Vermont Agency of Transportation

X	Reviewed	Furnish As Corrected
_____	Rejected	Revise and Resubmit

WEB CUTTING AND FLANGE BENDING DIAGRAMS FOR GIRDERS 6G1B, 7G2B, 8G3B, 9G4B, 10G5B AT SOUTH LEG GIRDERS 6G5D, 7G4D, 8G3D, 9G2D, 10G1D AT NORTH LEG

DESCRIPTION: CAMBER DIAGRAMS	
CASCO BAY STEEL STRUCTURES, INC. 1 WALLACE AVE. SOUTH PORTLAND, ME 04106 PHONE (207) 780-6722 FAX. (207) 780-6726	
STRUCTURE: VT 100 OVER LAHOILLE RIVER MORRISTOWN, VT LAHOILLE COUNTY STP F 029-1 (2) C/1	DRAWN: NJG DATE: 08/07
LOCATION: MORRISTOWN, VT	CHKD: SOB DATE: 08/09
PROJ NO. STP F 029-1(2)C/1	JOB NO. 521
CUSTOMER: MINTERSET, INC.	DWG NO. C2 REV. 1

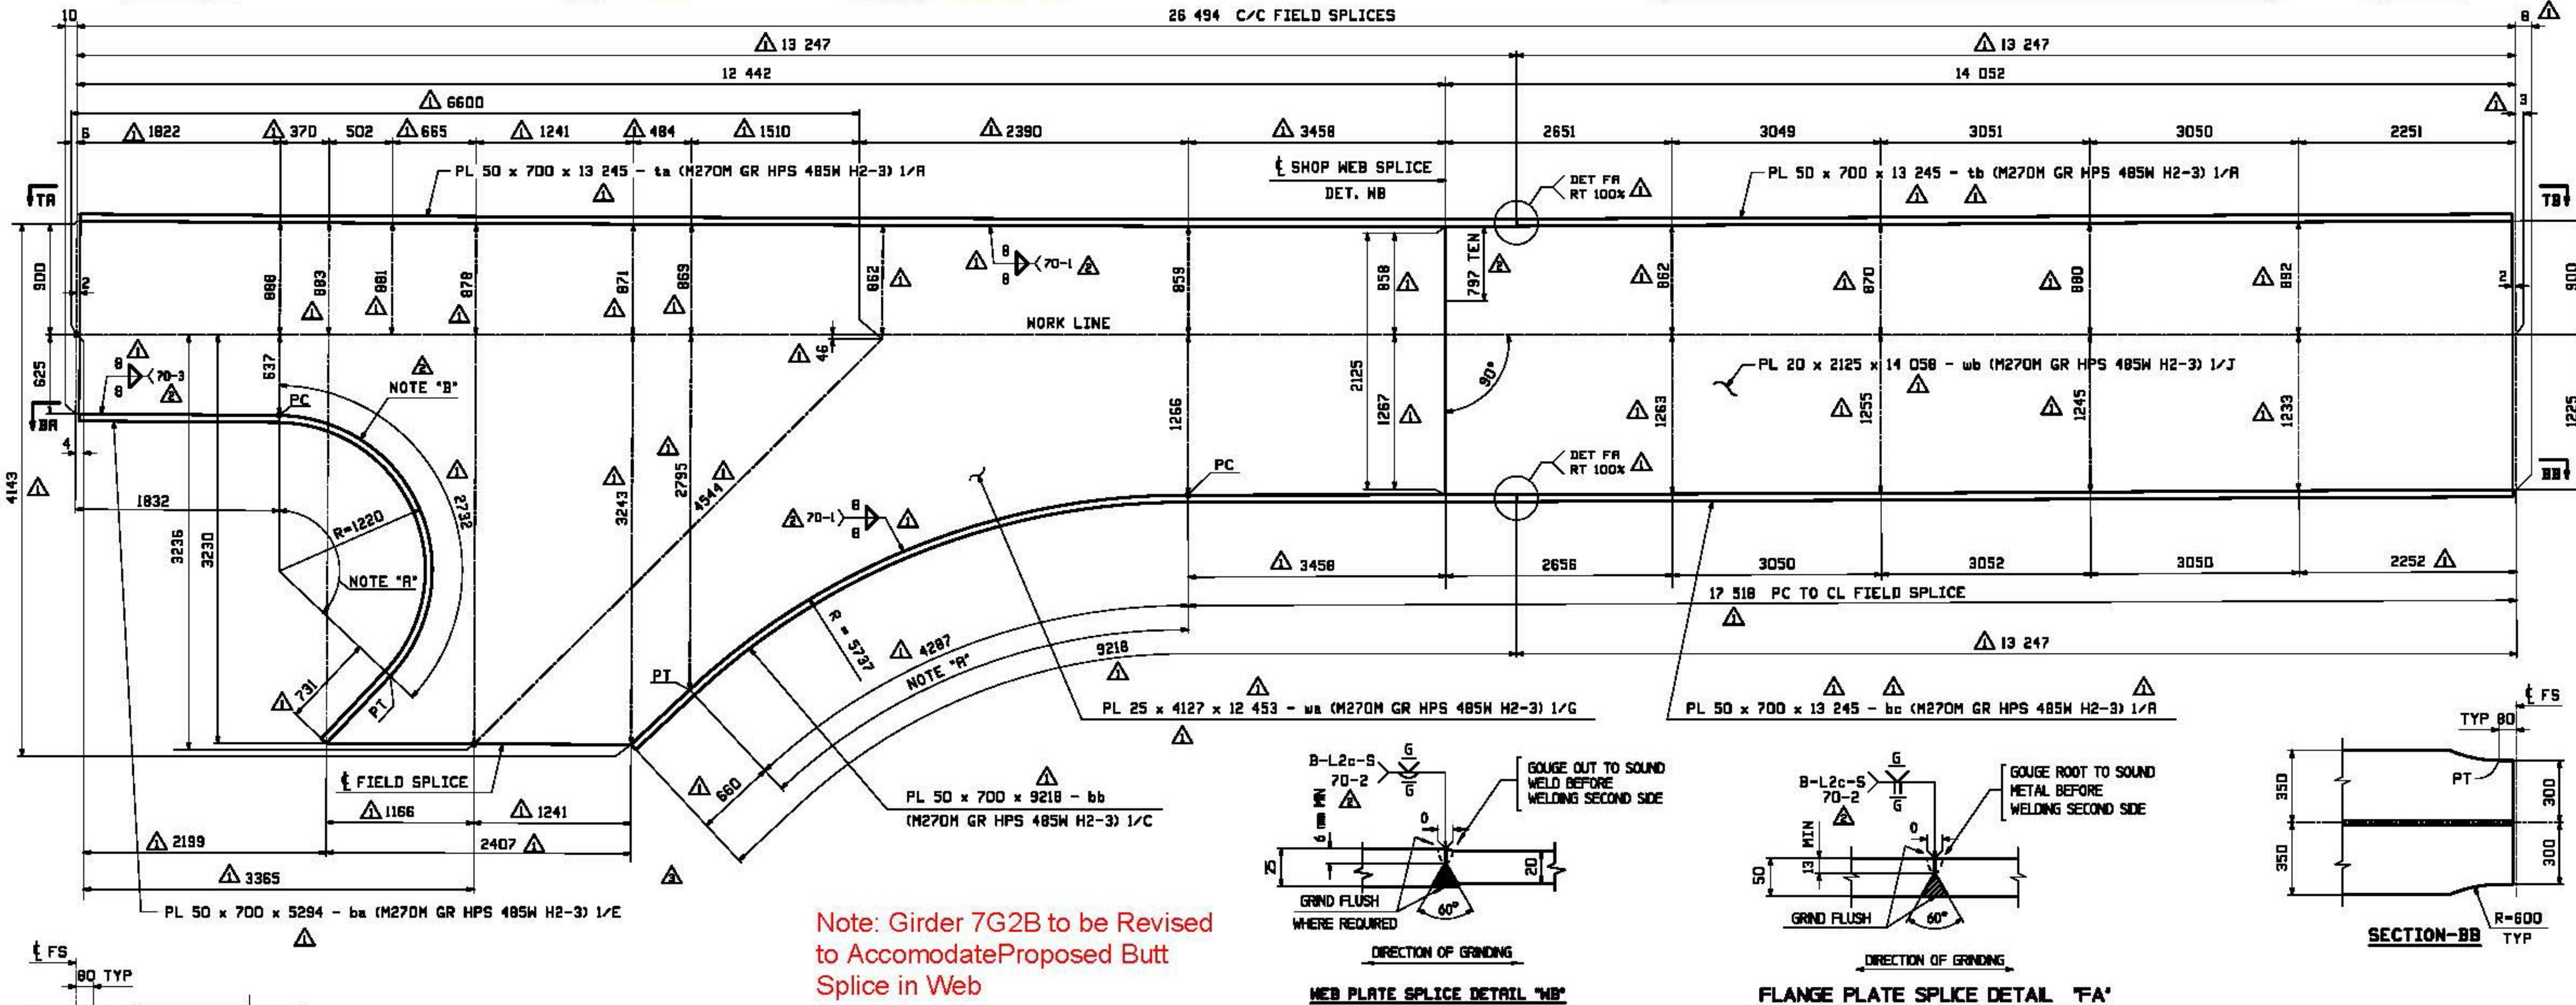
Note: Girder 7G2B to be Revised to Accomodate Proposed Butt Splice in Web

NOTE "A"
CURVED AREA OF FLANGE PLATE TO BE UT TESTED AFTER ROLLING

NOTE "B"
BEFORE HOT OR COLD BENDING, THE CORNERS OF THE PLATE SHALL BE ROUNDED TO A RADIUS OF 1/4" THROUGHOUT THAT PORTION OF THE PLATE AT WHICH THE BENDING IS TO OCCUR (TYP).
